Powerfuel Portland Ltd

Schedule 5 Response No 1

Figure 1: Frequency Scatter and Quantile-quantile Plots - Lovett Power Plant Validation Study

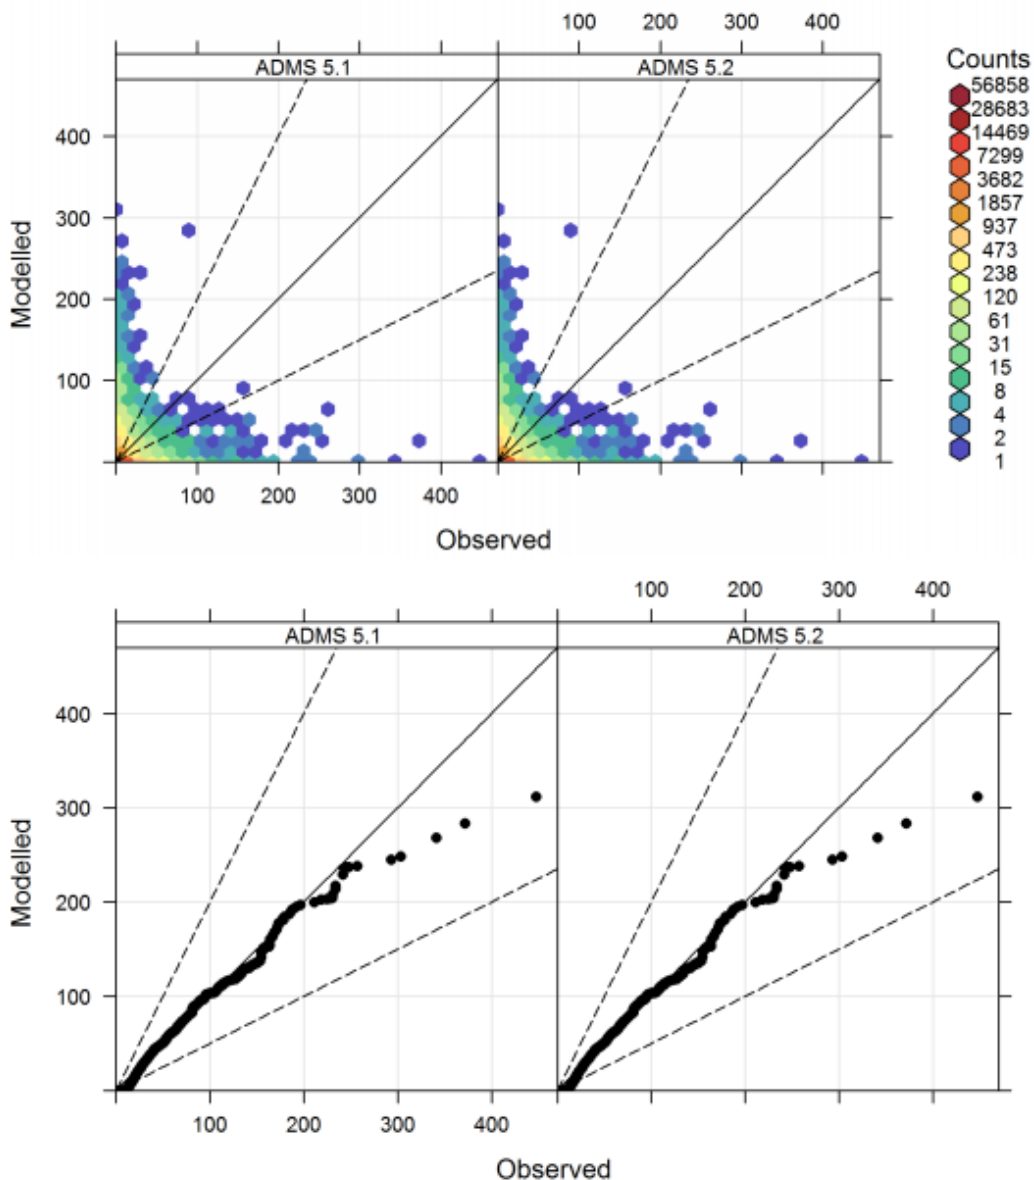
The scatter plot and quantile-quantile plots (Figure 1) show a relatively good agreement between the modelled and observed concentrations for ADMS 5.2 with only a few of the higher concentrations being under predicted in ADMS.

Client:	Powerfuel Portland Limited
Site:	Portland
Project:	2953
Title:	
Figure 5 Slope Analysis	
Drawn by: RSF	Date: 15/11/2021
© Crown copyright database right 2021

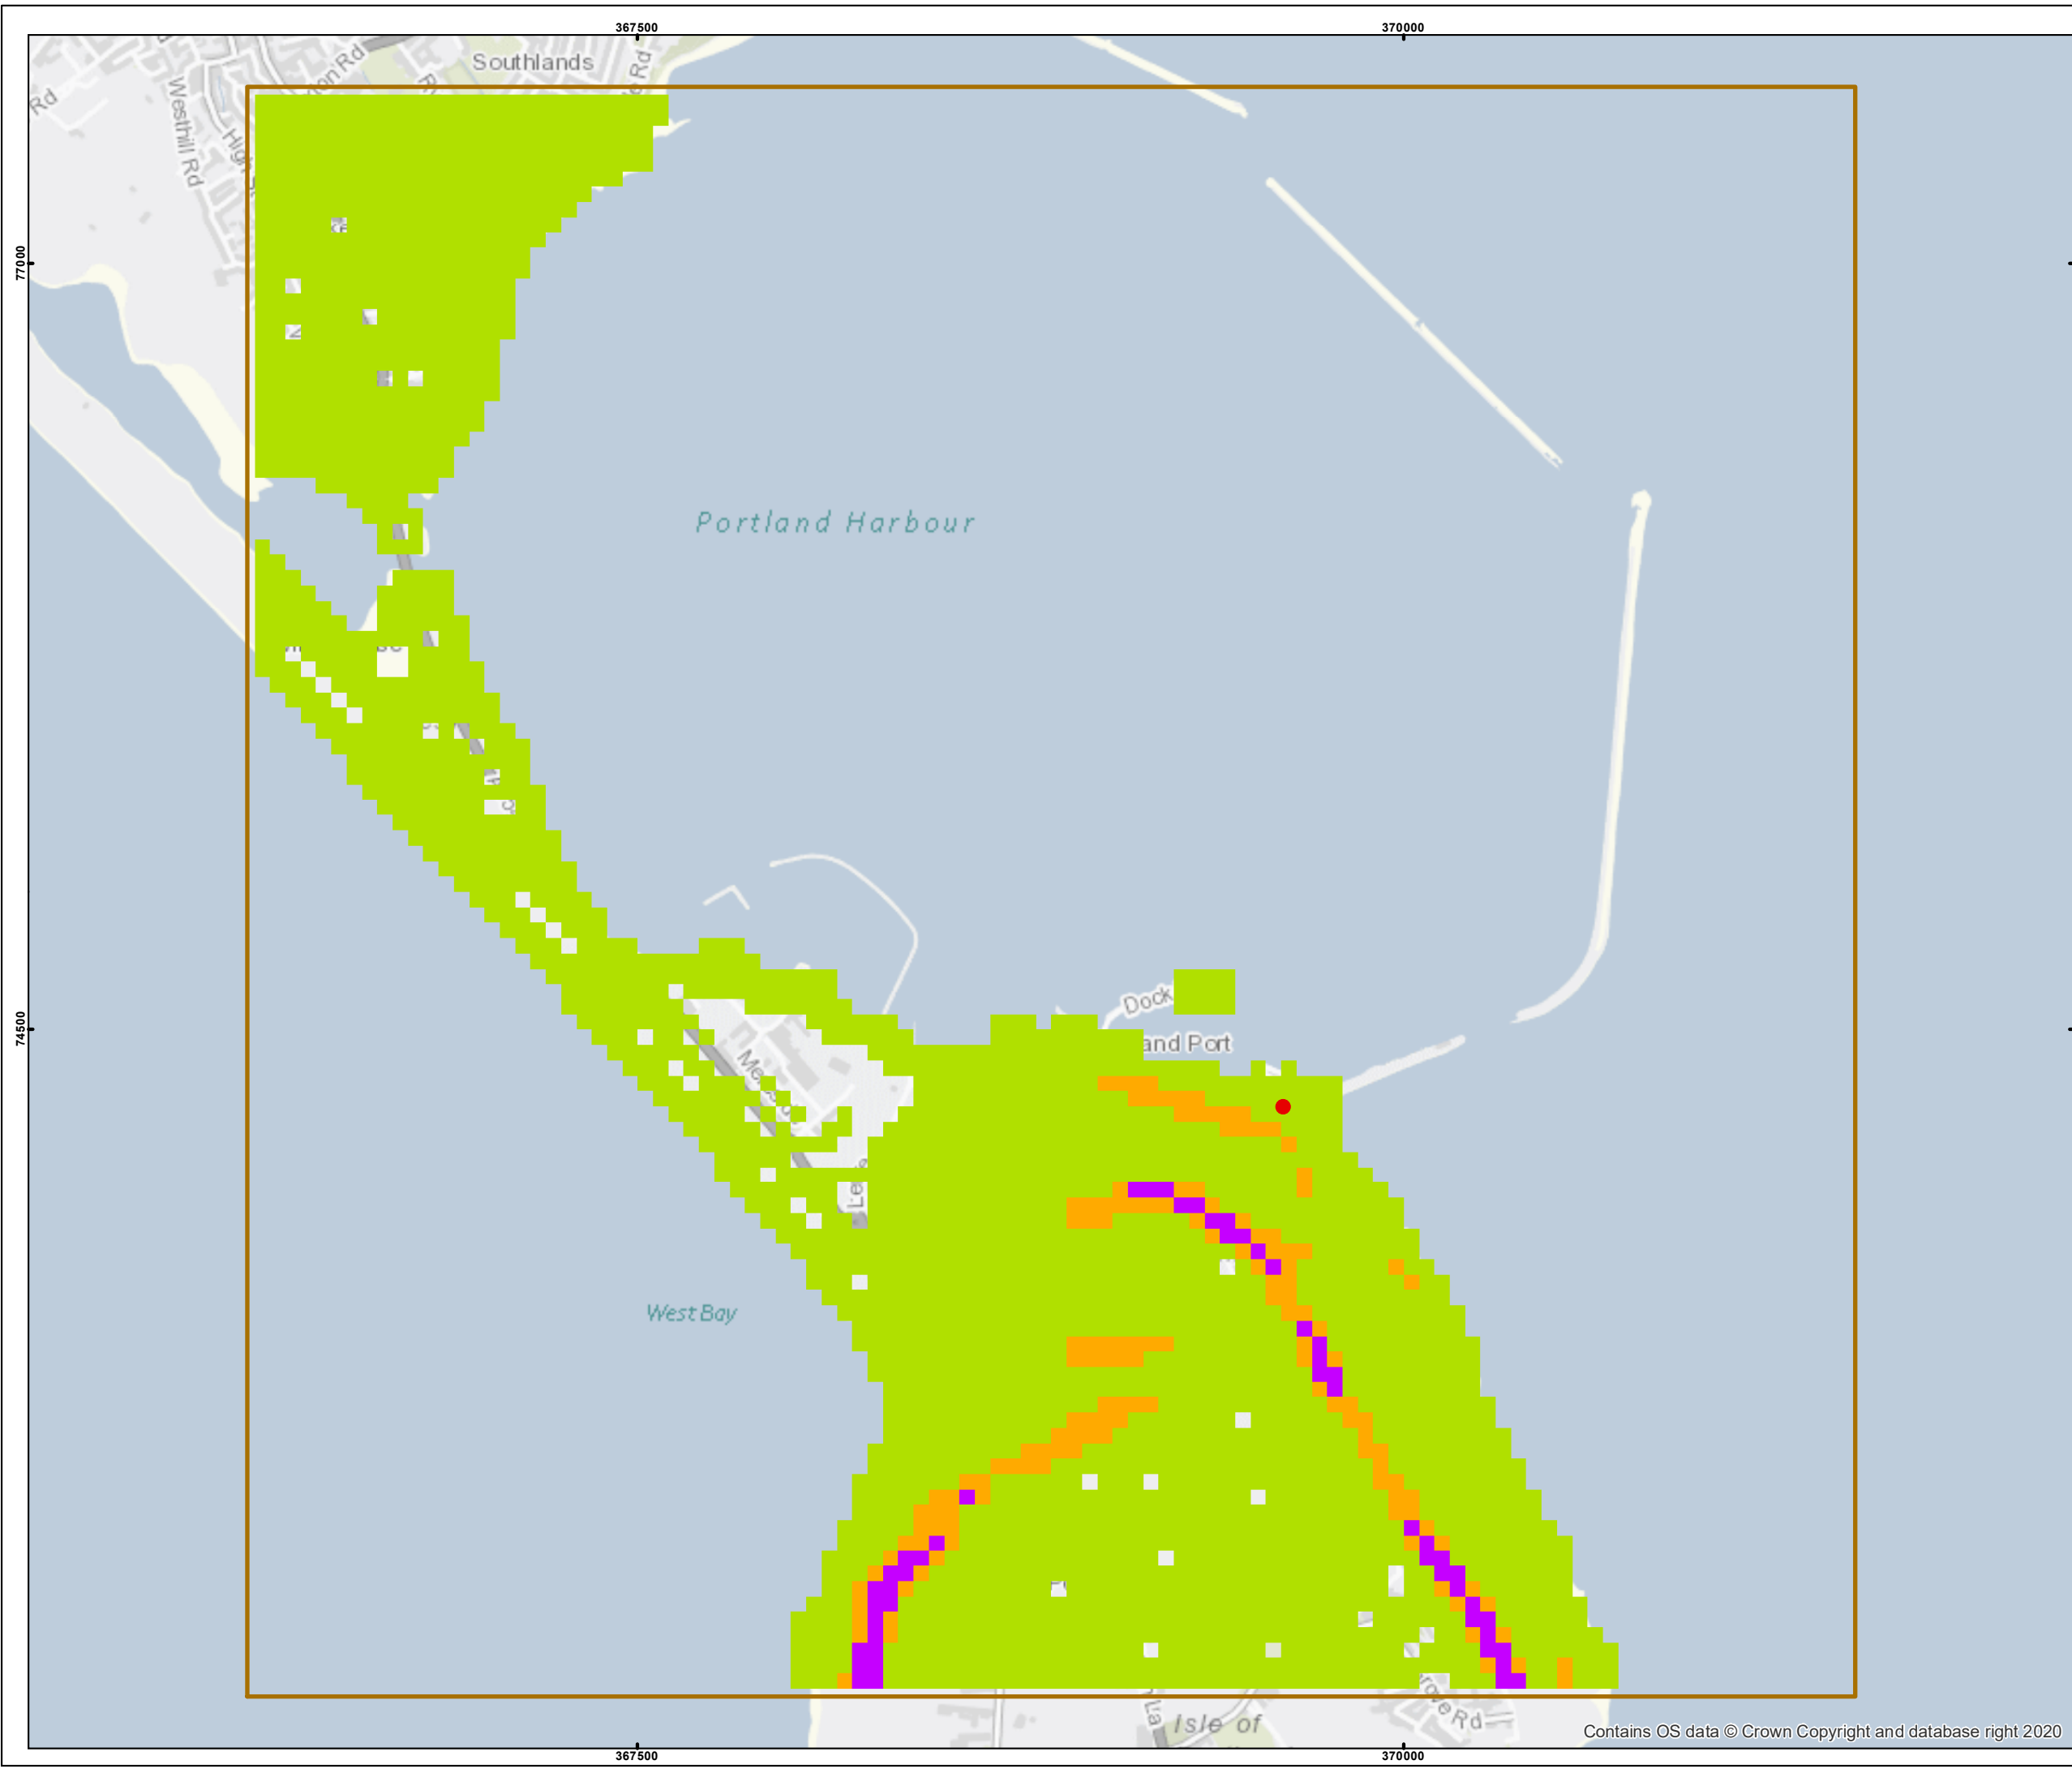
Figure 5 contained in Appendix A shows the Ordnance Survey Terrain 50 data and identifies the areas where terrain slopes are greater than 1:3 in orange, and greater than 1:2 in red. As shown the majority of the area the terrain slopes are less than 1:3. The hill to the west of the Portland ERF the slope is just over 1:3 but within the 1:2. This shows that there are only small areas where the terrain slopes are outside of the range of 1:2.

Figure 6:
Minimum Monin Obukov Length
Sensitivity Analysis

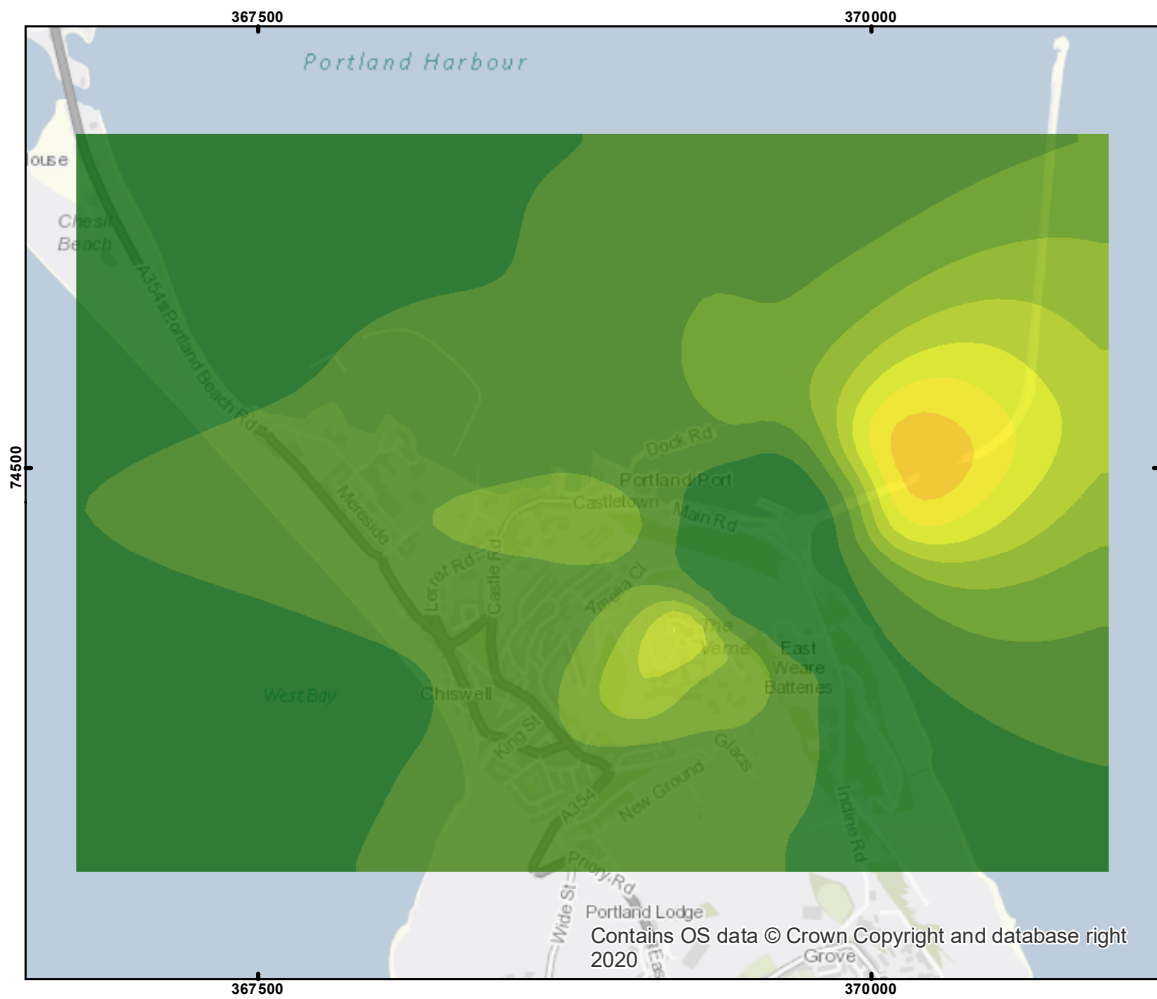
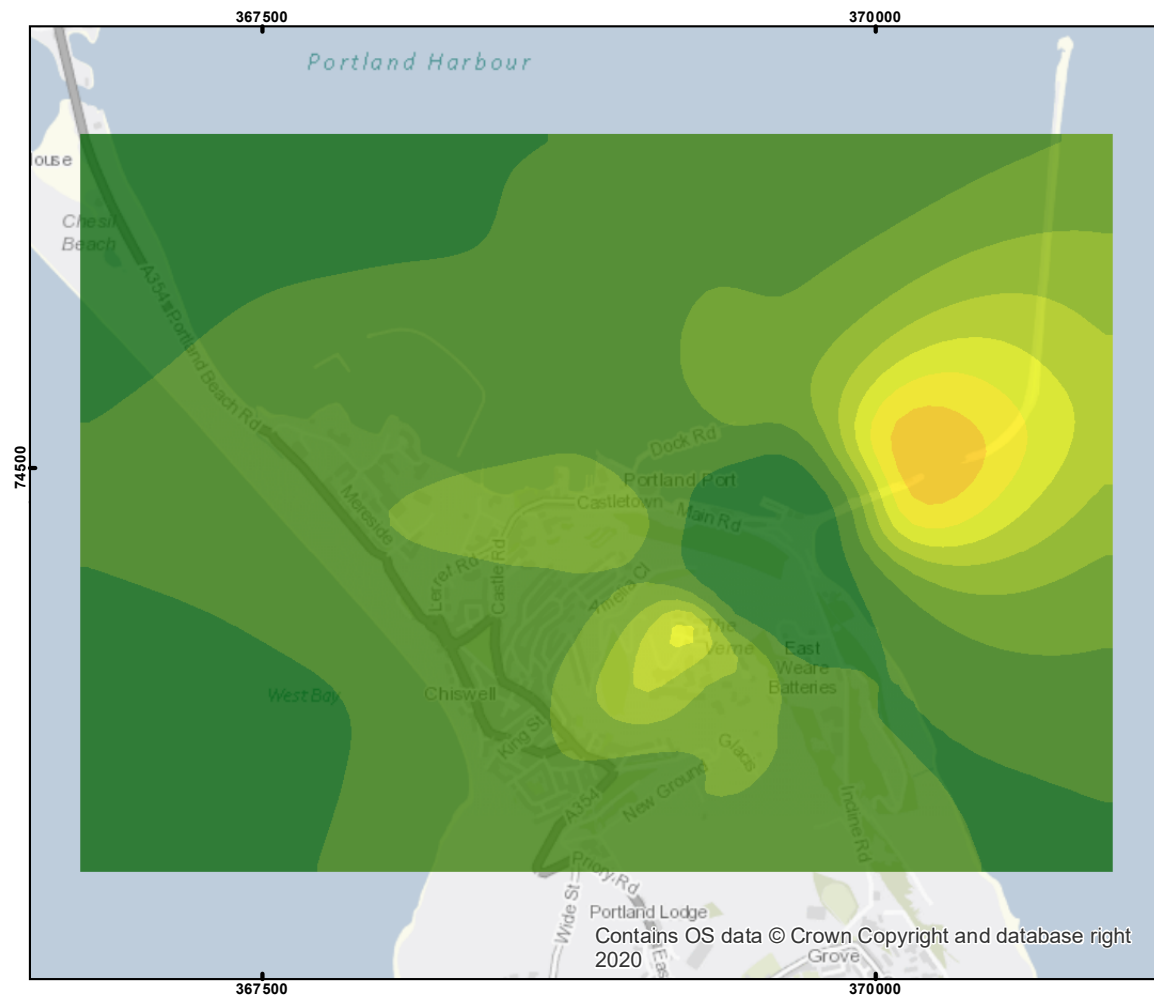
The contour plots presented in Figure 6 to Figure 8 contained in Appendix A show that there is very little difference in the distribution of emissions on an annual mean or 24-hour basis. There is some difference in the distribution of peak 1-hour concentrations with the peak concentration predicted to occur closer to the stack with the higher minimum Monin-Obukov length.

Figure 9
Met Site Surface Roughness Length
Sensitivity Analysis

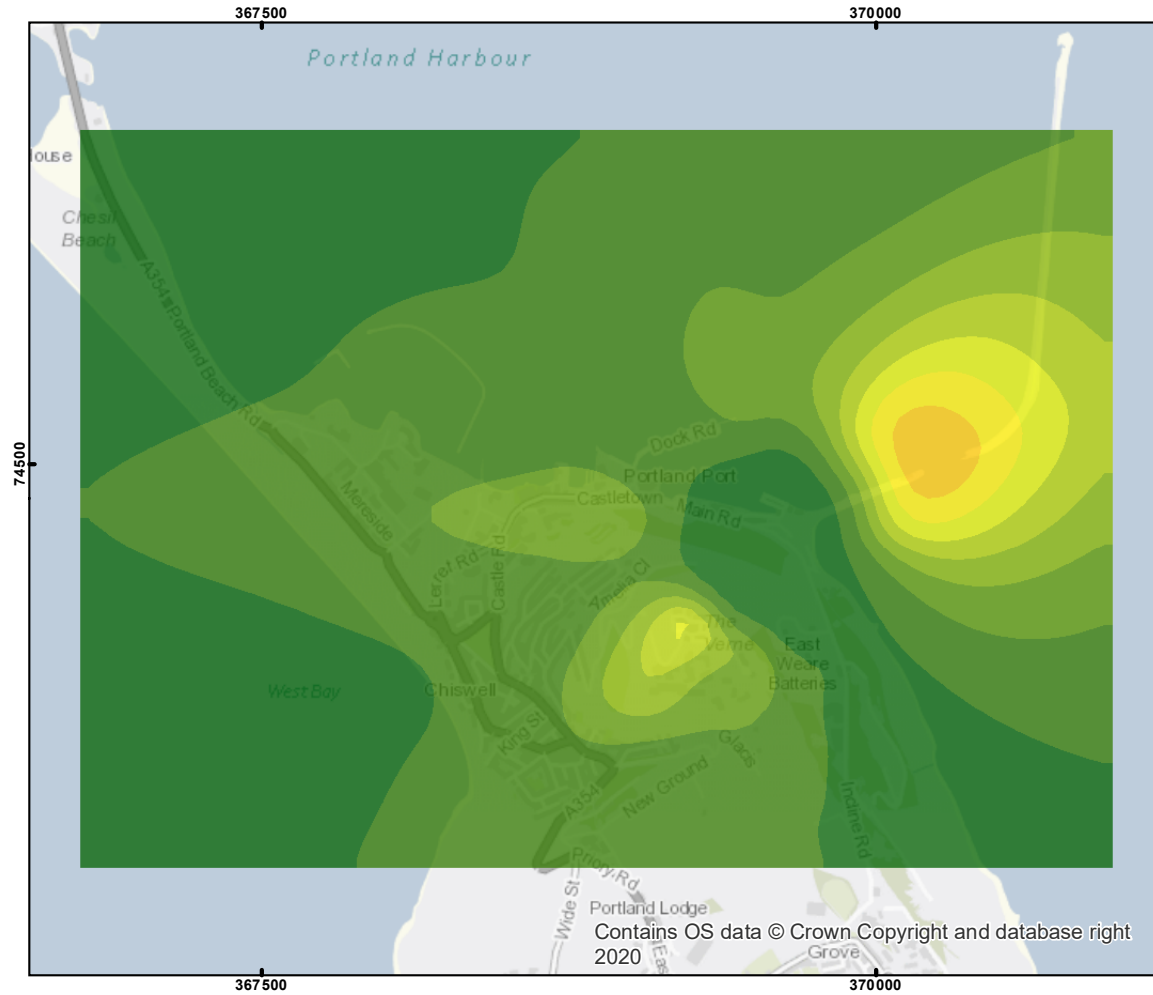
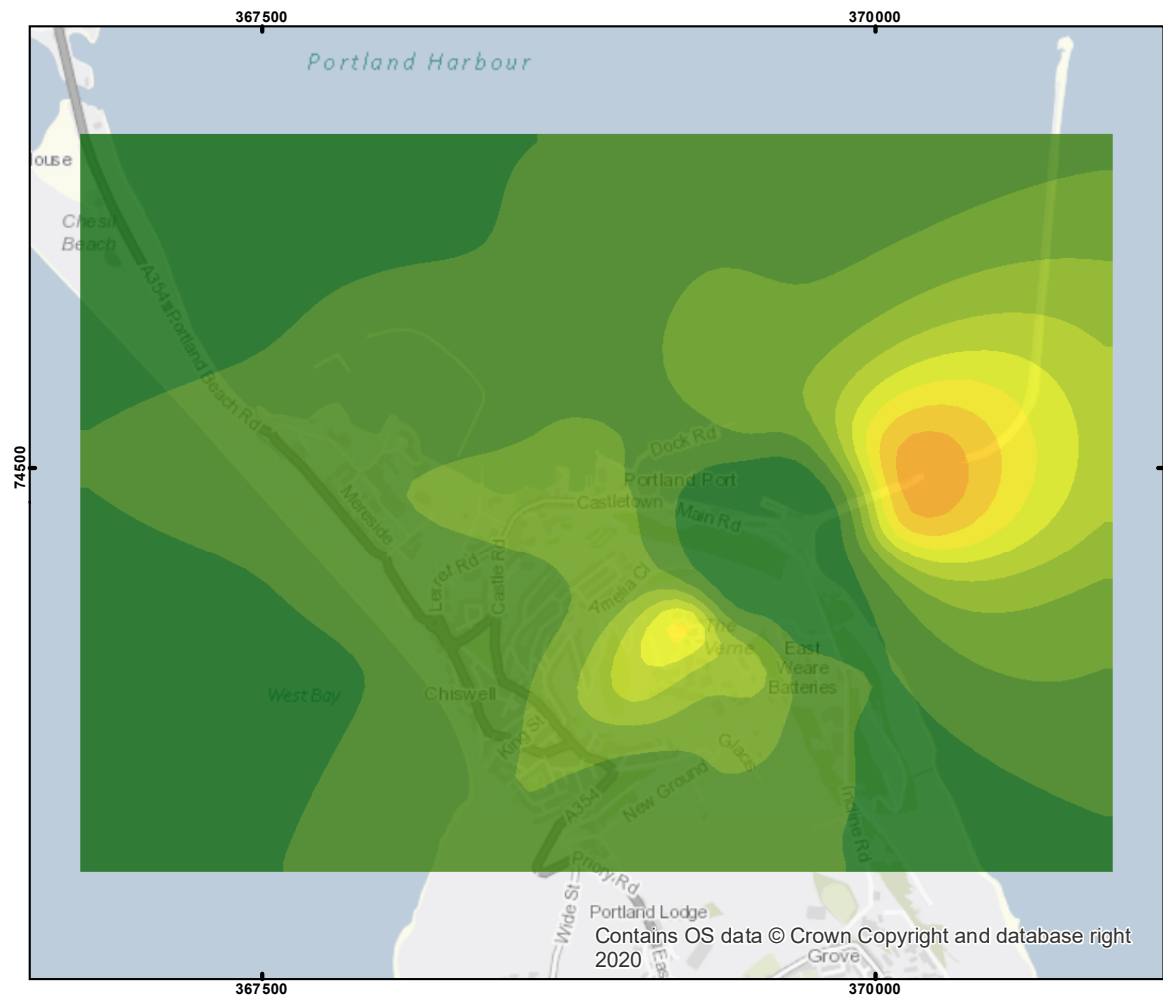
As shown the choice of surface roughness length for the meteorological site has a slight effect on the predicted impact. The predicted maximum impact is generally greater with the higher surface roughness value for the meteorological site with the exception of the peak 1-hour concentration which is lower closer to the stack. Whilst the change as a percentage of the value used in the DMA is in some instances up to 40% greater (maximum 24-hour mean), the distribution of impacts is similar as shown in Figure 9 to Figure 11 contained in Appendix A.
